Page	**Place**	**Error**	**It should be**
3	paragraph Compliance	This means that the deformation is stiffness times load.	This means that the deformation is compliance times load.
20	above figure 10.14	a factor 1.5.	a factor 3.
23	formula 10.14, line 2	$= \int_{-\frac{1}{2}h^2}^{\frac{1}{2}h} \frac{1}{2} \frac{\sigma_{max}^2 \cdot 4z^2}{Eh^2} bLdz = \left[\frac{1}{2} \frac{\sigma_{max}^2 \cdot 4z^3}{3Eh^2} bL\right]_{-\frac{1}{2}h}^{\frac{1}{2}h}$	$= \int_{-\frac{1}{2}h}^{\frac{1}{2}h} \frac{1}{2} \frac{\sigma_{max}^2 \cdot 4z^2}{Eh^2} bLdz = \left[\frac{1}{2} \frac{\sigma_{max}^2 \cdot 4z^3}{3Eh^2} bL\right]_{-\frac{1}{2}h}^{\frac{1}{2}h}$
26	formula 10.25	$\sigma(\rho, y, \varphi) = 0 \qquad \tau(\rho, y, \varphi) = \tau_{max} \cdot \frac{2z}{t}$	$\sigma(x, y, z) = 0 \qquad \tau(x, y, z) = \tau_{max} \cdot \frac{2z}{t}$
27	formula 10.26	variable h	variable t
28	thickness in figure of thin tube	$t = q$	$t = \frac{q}{2}$

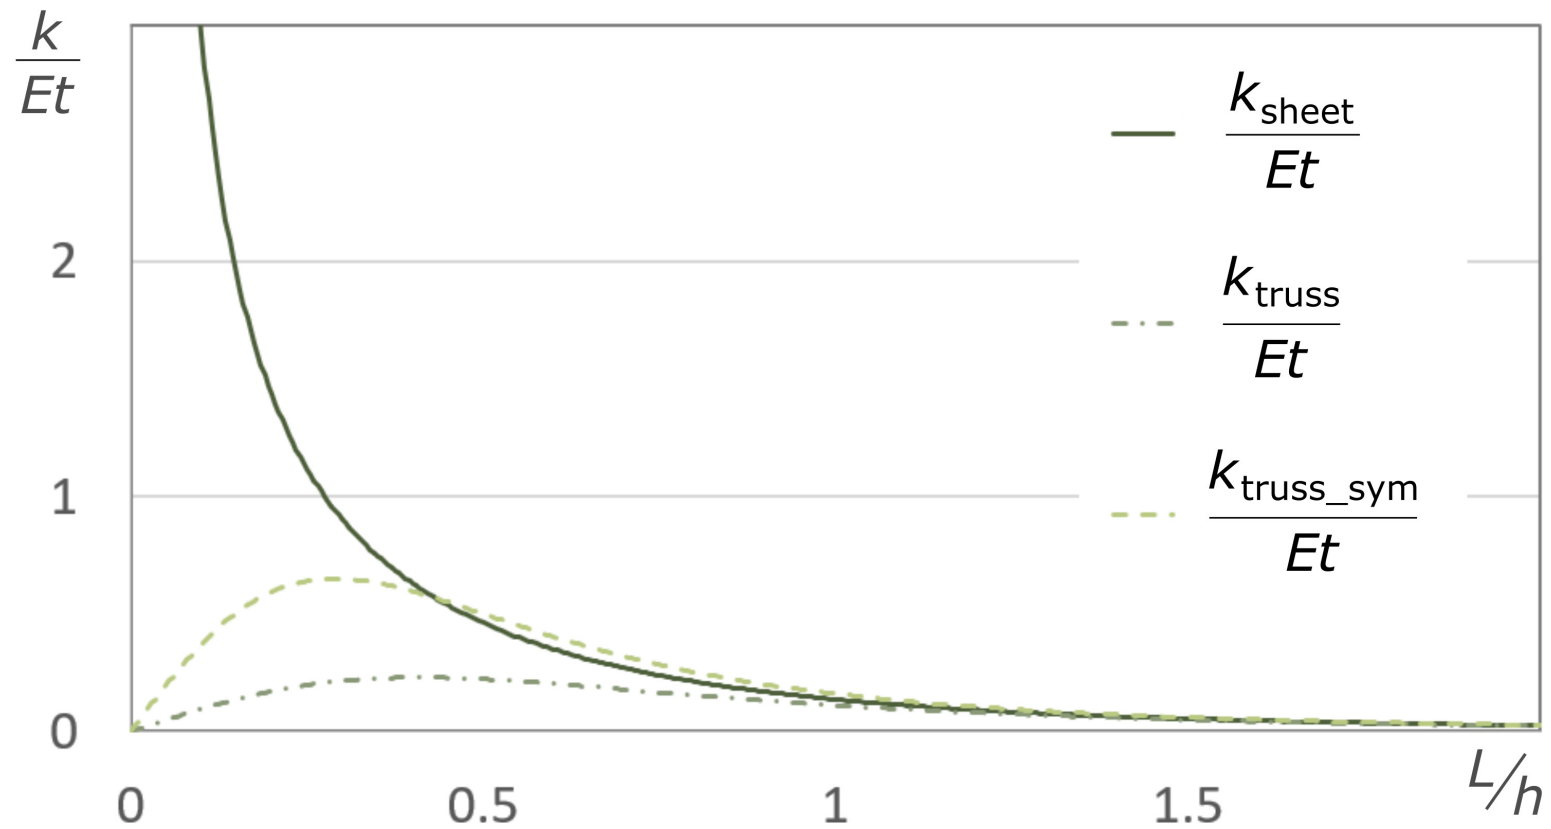
Page	**Place**	**Error**	**It should be**
31	line two from bottom of page	stiffness almost the same as the stiffness of the sheet	that is not the case, it is not almost the same
32	figure 10.34	stiffness of symmetrical truss should be as in figure:

32	equation 10.36	equation of stiffness is wrong	$k_{\text{truss2}} = \dfrac{4ELh^3t}{16L^4 + 8L^2h^2 + h^4}$
33	first sentence	stiffness almost the same as the stiffness of the sheet	that is not the case, it is not almost the same
37	formula 10.47	$\left(12a^2 - 12 + 4\right)\dfrac{EI}{L}$	$\left(12a^2 - 12a + 4\right)\dfrac{EI}{L}$
38	formula 10.48, line 3 and 4	$\left(12a^2 - 12 + 4\right)$	$\left(12a^2 - 12a + 4\right)$
